DEVELOPMENT ASSESSMENT REPORT	
Application No.	DA/2022/0556
Address	18 Batty Street ROZELLE NSW 2039
Proposal	Construction of carport, garbage store, stairs, fence and storage area adjacent to Batty Street frontage
Date of Lodgement	19 July 2022
Applicant	GM Architects Pty Ltd
Owner	Matthew Khouri
Number of Submissions	3
Value of works	\$13,153.00
Reason for determination at Planning Panel	Breach of Development Standards - Landscaped Area, Site Coverage (>10%)
Main Issues	Landscaped Area Site Coverage Parking Heritage Design
Recommendation	Refusal
Attachment A	Reasons for refusal
Attachment B	Plans of proposed development
Attachment C	Statement of Heritage Significance
Attachment D	Conditions in the event of approval

1. Executive Summary

PROPOSED ON-STREET PARKING
5 spaces available

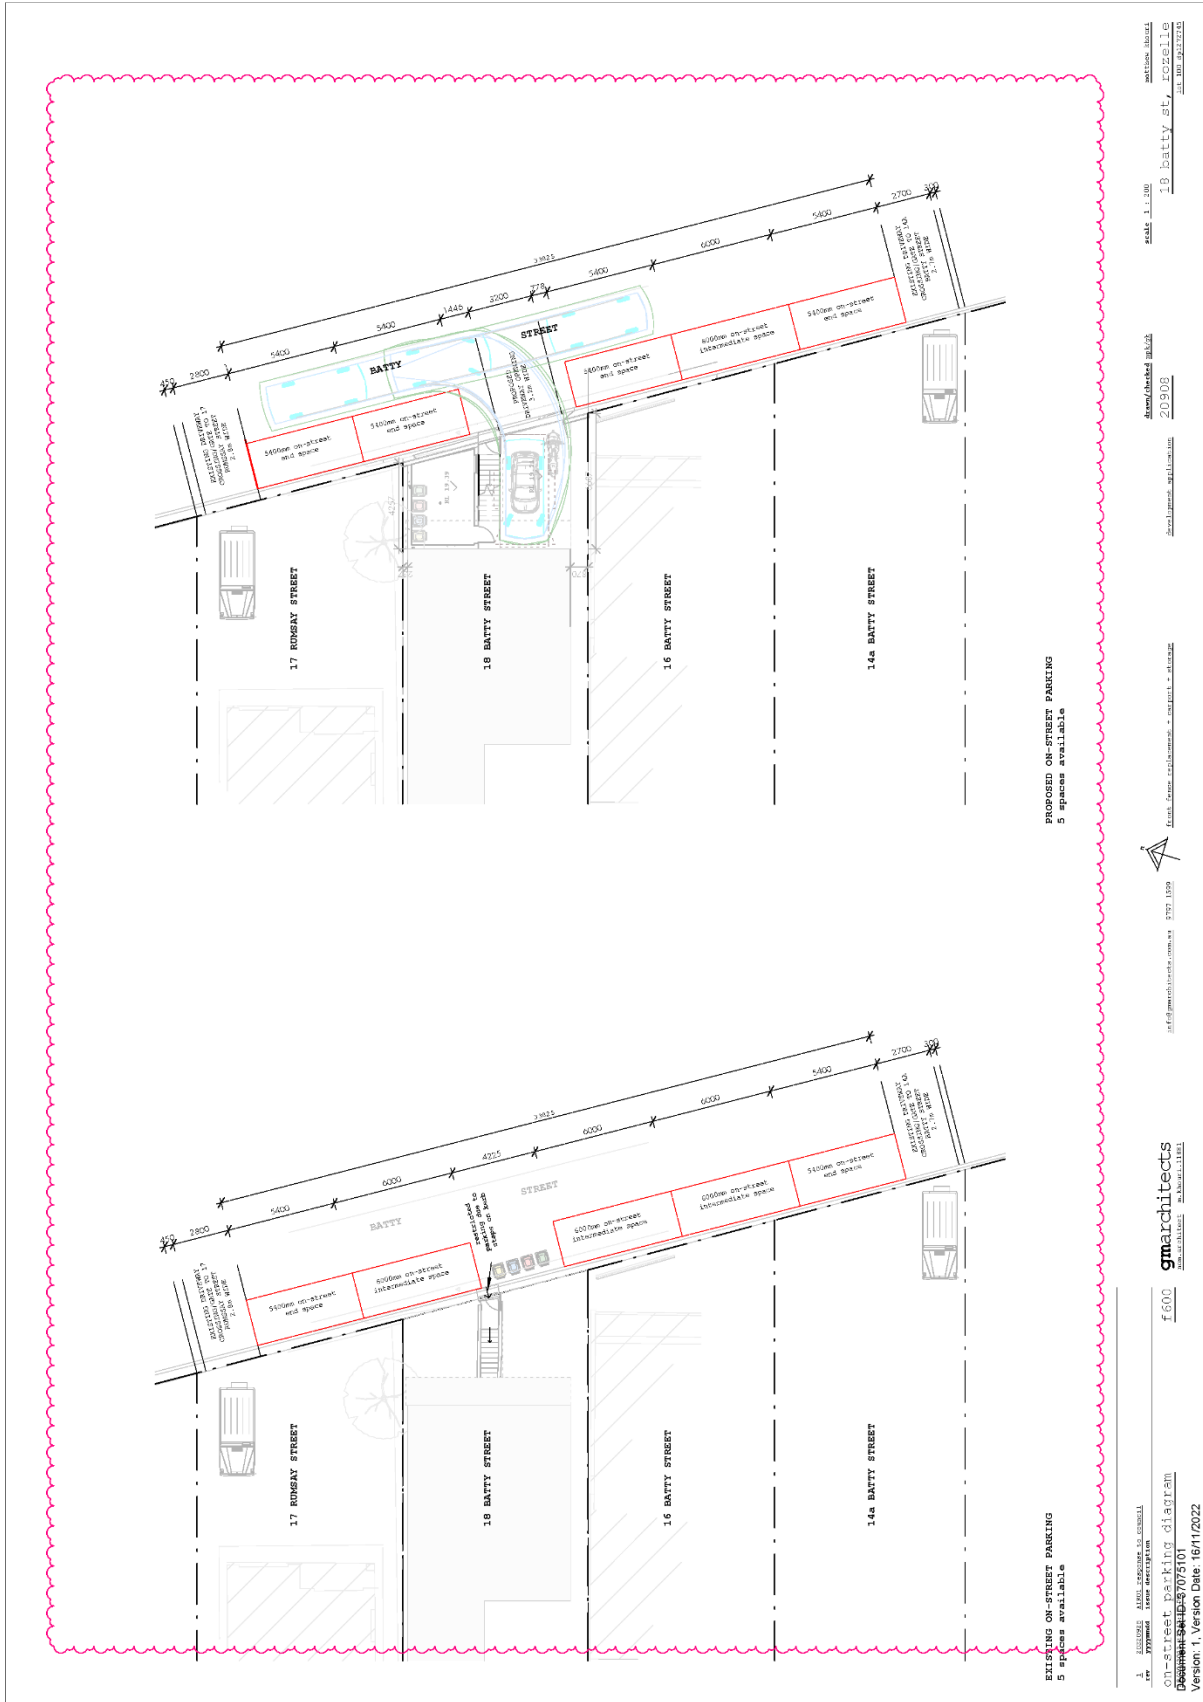
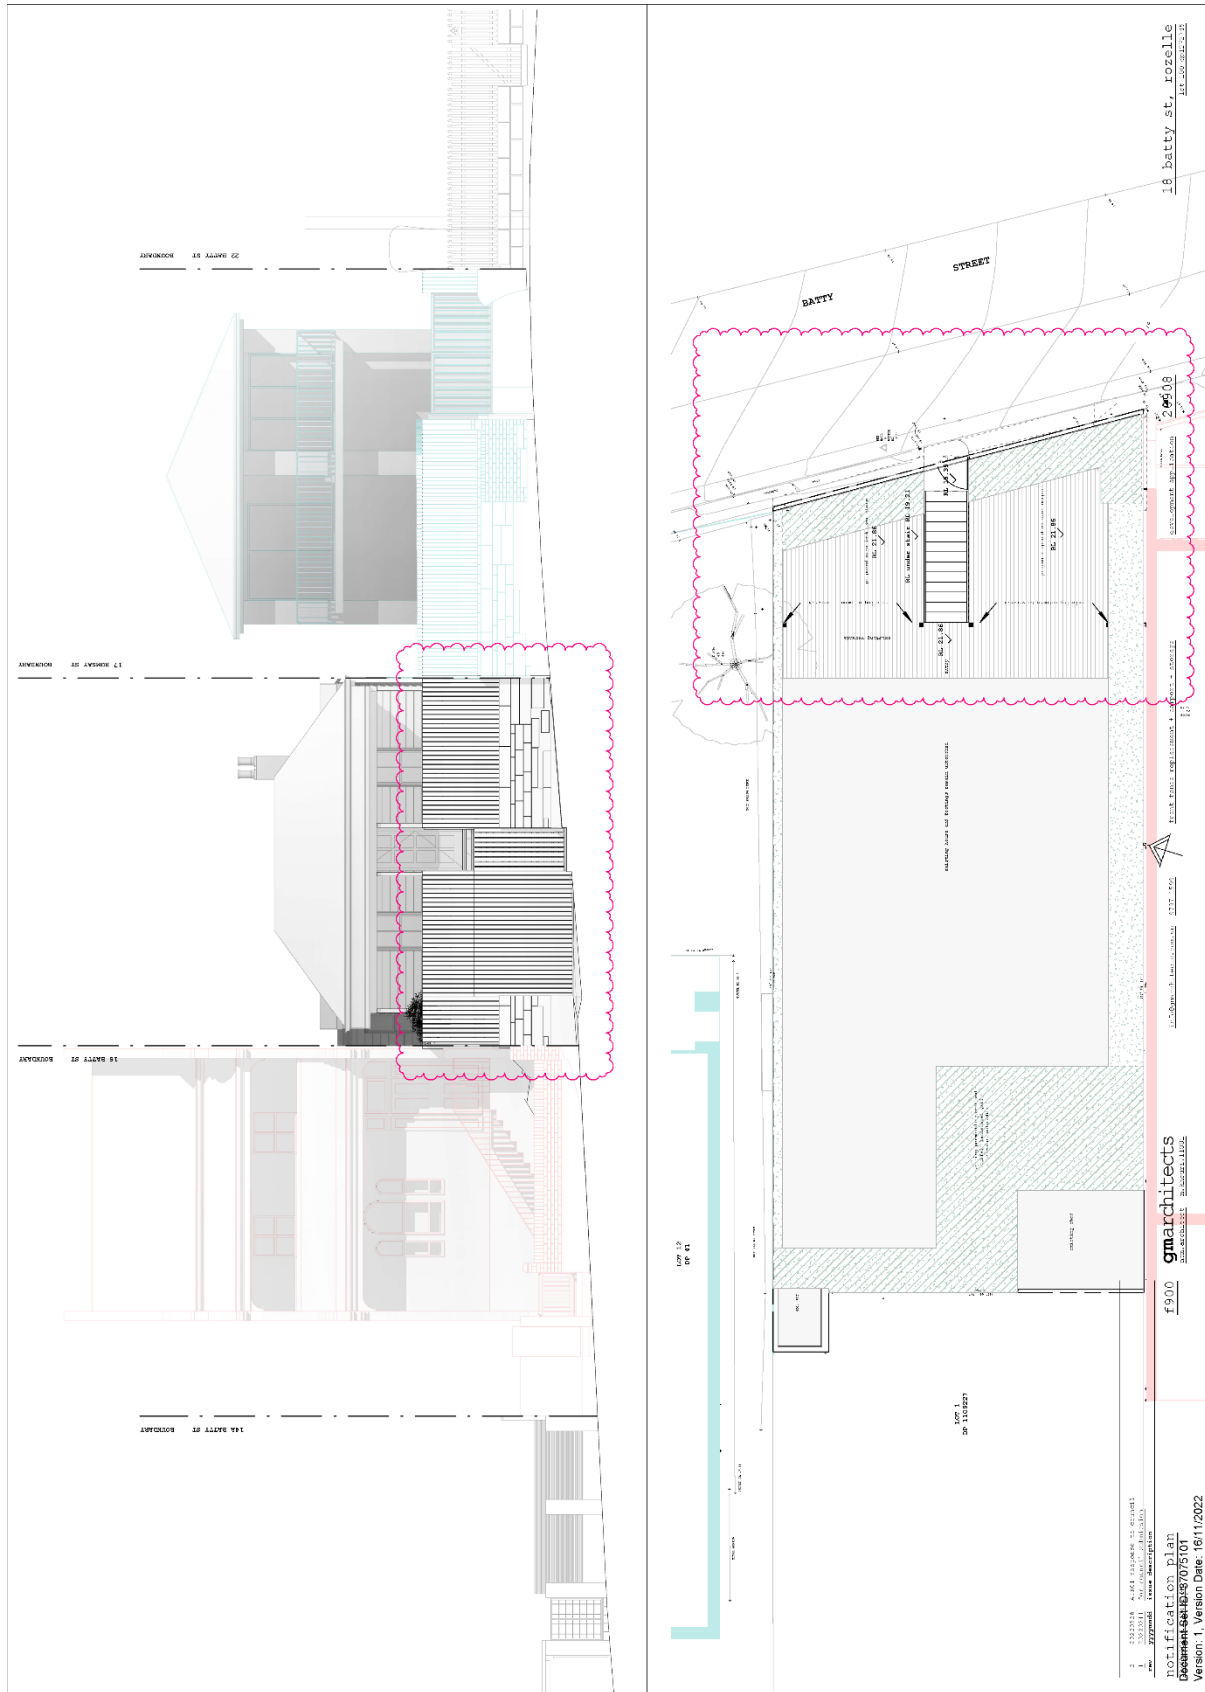
The proposed off-street parking is not supported as it will result in a loss of existing on-street public parking. This is contrary to control C49 of Part C1.11 of the Leichhardt DCP.

In this regard, the layout of the proposed on-street parking as detailed in the application indicates parking spaces set out hard up against the vehicle access driveways of both 14a Batty and 17 Rumsay Street. Given the narrow width of Batty Street this would make it difficult for a B85 vehicle to enter and leave these properties. This was evident from site inspection as owners have painted lines on the road to ensure vehicles to not park too close to the driveways.
